Norwich to Tilbury

**Document: 8.3.65 Signed Statement of Common Ground -
Southfields Development Group - Tracked Changes Version**

Planning Inspectorate Reference: EN020027

Southfields Development Group

Image 7.1 Interaction between TB259 to TB261, ~~highlighted in pink is the inner consultation zone of the Gas line, highlighted in blue is the outer consultation zone~~ and the Southfields development

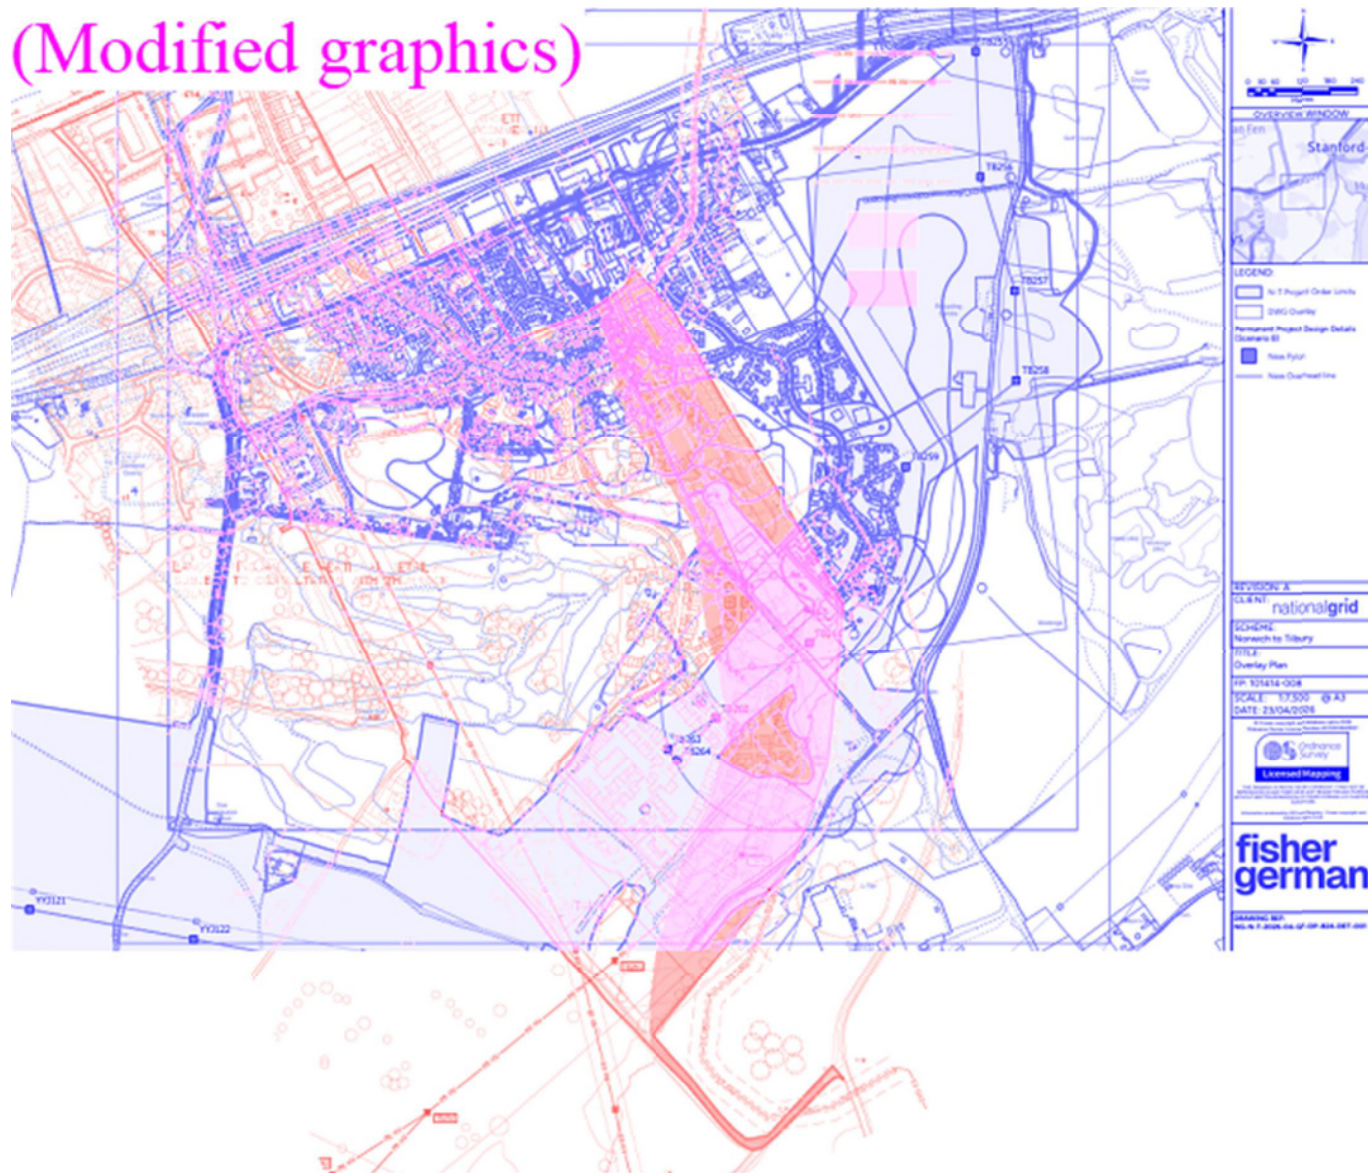
<u>ID</u>	<u>Issue</u>	<u>National Grid position</u>	<u>Southfields Development Group position</u>
<u>7.19</u> <u>.1</u>	<u>Pylon- Positions Route alignment, pylon positions and oversail</u>	The Applicant acknowledges Southfields Development Group's concerns regarding the alignment of the proposed overhead line and its potential interaction with the village and wider regeneration proposals. Throughout the design process, the Applicant has sought to identify an alignment that minimises impacts where practicable. In particular, efforts have been made to keep the overhead line as close as possible to the existing gas pipeline corridor, thereby limiting the extent of additional land affected and consolidating infrastructure where feasible. However, there are a number of technical and environmental constraints that limit flexibility in this location. Due to local topography and ground conditions, it has not been possible to route the line across the landfill. These constraints significantly restrict the range of alignment options in this area. With regard to tower position TB261, its location has been determined through detailed engineering design, including span	theThe 'line' presently shown as running across the southern part of the 800 dwelling village site, and the Thurrock Council owned filled refuse tip, which is to the immediate east of the village site, blight the whole of the village site to the point of making the proposed dwellings unsaleable, in addition the agreement for Thurrock Council and National Grid to jointly participate in regeneration of the 80 acre filled tip area would also be prejudiced by the presently proposed positions of two of the new pylons and the proposed pylon line. Prima facie it looks as if the new pylon cable line could continue further south along the east side of Buckingham Hill Road to cross the BHR just to the south of the junction of Holford Road with the Buckingham Hill Road. The latter line would remove the blighting effect upon the proposed village site and the regenerated for recreation purposes Buckingham Hill Road 'Council owned refuse tip, while occupying land which is presently vacant and unlikely to ever be considered for residential development. I cannot see any material difference in the

<u>ID</u>	<u>Issue</u>	<u>National Grid position</u>	<u>Southfields Development Group position</u>
		length, safety, and structural requirements. Relocating this tower outside of the refuse tip area is not feasible without exceeding acceptable span distances or necessitating additional infrastructure, which could result in greater overall environmental and visual effects. <u>With regards to tower TB259, there are restrictions as to possible relocation due to the presence of a high-pressure gas main to the east of the proposed location.</u> The Applicant notes the concerns raised in relation to the potential implications for the proposed development and has, to date, sought to take account of emerging master planning where reasonably practicable within the design process. However, given the constraints outlined above, there is limited scope for further modification to the alignment in this area. The Applicant remains committed to ongoing engagement with stakeholders and will continue to consider any reasonable opportunities to reduce effects where practicable <u>through detailed design</u>.	construction cost to 'Grid of the overhead line as presently indicated, as against moving the 'line' to continue further south along the east side of Buckingham Hill Road. Given the height, substantial nature and position of the pylons and the 'line' as presently proposed, my proposed scheme for the new Southfields Village and a Country Park which will, all being well, include the regenerated refuse tip as referred to above, will not be viable. People do not like living near pylons and overhead lines and the incidence of the proposals as presently indicated, albeit over a very small length of the overall 'line', renders the ten years of work spent upon creating the new 'Village and Country Park, and obtaining local residents support, as completely wasted.
